SUMMARIZATION OF NEW APPENDICES (B, C, D, E, F, G, H)

REVISION: C (supersedes Rev B, dated June 2, 2026)

DATE: June 15, 2026

RE: Supplemental Public Comments and Risk Assessment regarding the Proposed 20 MGD Wastewater Treatment Facility

Exhibit C-1: 0.5-mile, 1.0-mile, and 2.0-mile rings centered on 3230 Mann Road, plotted on the TDEC Water Wells Desktop Application map. Each dark dot represents a permitted private water well in the TDEC database.

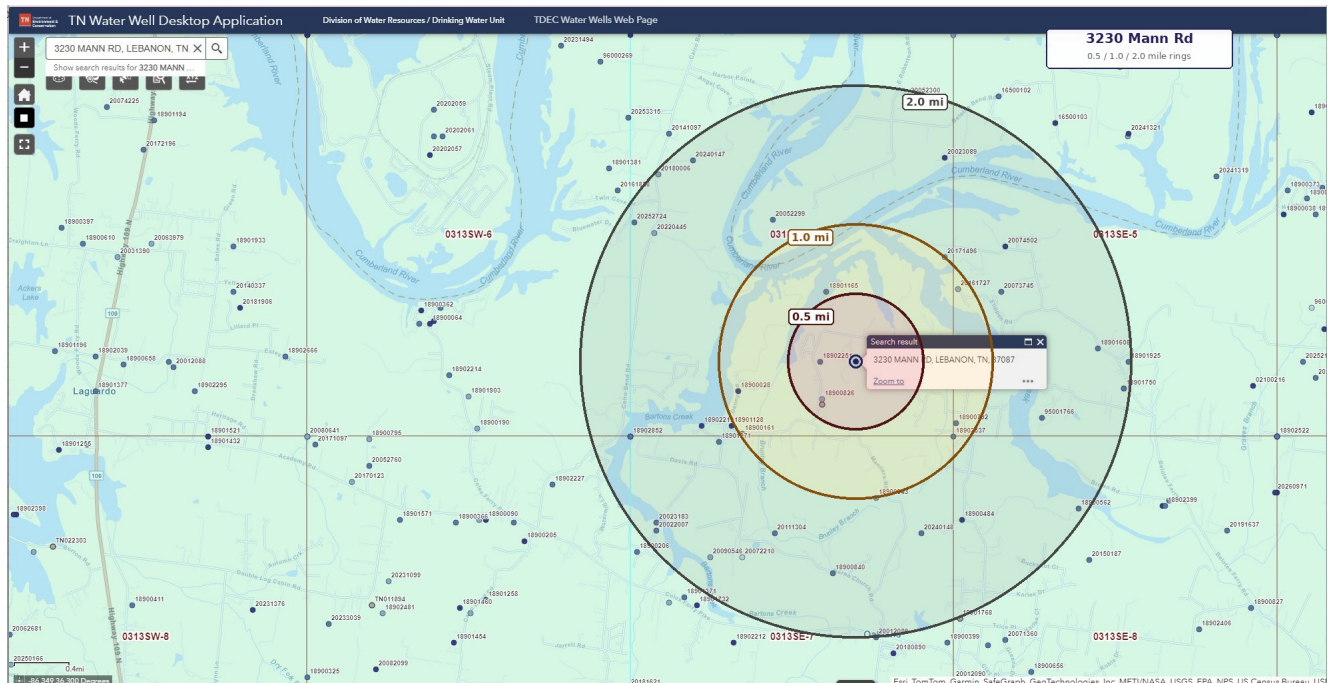
A query of the Tennessee Department of Environment and Conservation (TDEC) Water Well Locations public database identifies **a minimum of 38 permitted private wells within the 2-mile contamination radius** surrounding the proposed Mann Road and Berea Church Road footprint. Of these:

- **6 wells are located within 0.5 miles** of a proposed site, including a well at 1079 Berea Church Road (Coster) situated approximately 850 feet (0.16 mi) from the Mann Road site;
- **16 wells are located within 1.0 mile** of a proposed site;
- **38 wells are located within 2.0 miles** of a proposed site, the outer boundary of the karst contamination radius identified in Section VI.

The geographic distribution of these wells, with concentric 0.5-mile, 1.0-mile, and 2.0-mile rings, is depicted in Exhibit C-1 below. Recorded uses include residential drinking water (32 wells), agricultural and irrigation (9 wells), and geothermal heat pump (3 wells). The Site Selection Committee has not, to the petitioners' knowledge, entered these figures into the public record.

Important caveat: The figure of 38 wells is a minimum. The TDEC Water Well Locations database includes only those wells for which a licensed driller filed a report. Wells drilled prior to the

- Formally request a hydrogeological study from a qualified third party documenting (or refuting) hydraulic connectivity between the proposed site footprint and the LUD well field;
- Require coordination with the LaGuardo Utility District Board of Commissioners as a prerequisite to any further consideration of the Mann Road and Berea Church Road addresses;
- Enter the well-count data and accompanying ring map (Exhibit C-1) into the official public record of the site selection proceedings, and supplement it with an independent staff verification against the most current TDEC Water Well Locations database;
- Provide written notification to each identified well owner, and to all LUD ratepayers, of the proposed siting and the karst-aquifer contamination pathway described in Section VI of the principal statement.
